Docket Number:	15-BSTD-02
Project Title:	Residential Compliance Manual and Documents
TN #:	205624
Document Title:	Airex Mfg. Suggested Change to Residential Compliance Manual
Description:	N/A
Filer:	Patty Paul
Organization:	Airex Mfg./Howard Ahern
Submitter Role:	Public
Submission Date:	8/3/2015 2:22:14 PM
Docketed Date:	7/31/2015

15-BSTD-02 2016 Residential Compliance Manual and Documents

Suggested Change to Residential Compliance Manual

Figure 4-1.

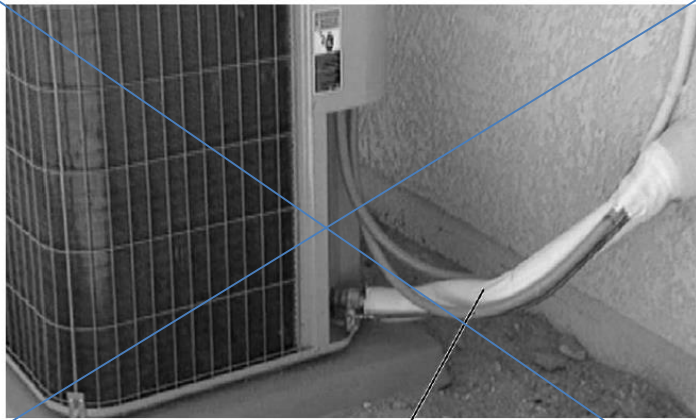
Vapor retarder & insulation protection

Justification –Photo should show suction line with an insulation system with a required vapor retarder. In addition it is against good practice (and against code in many jurisdictions in the US) to run the electric whips through the same penetration as the refrigerant lines.
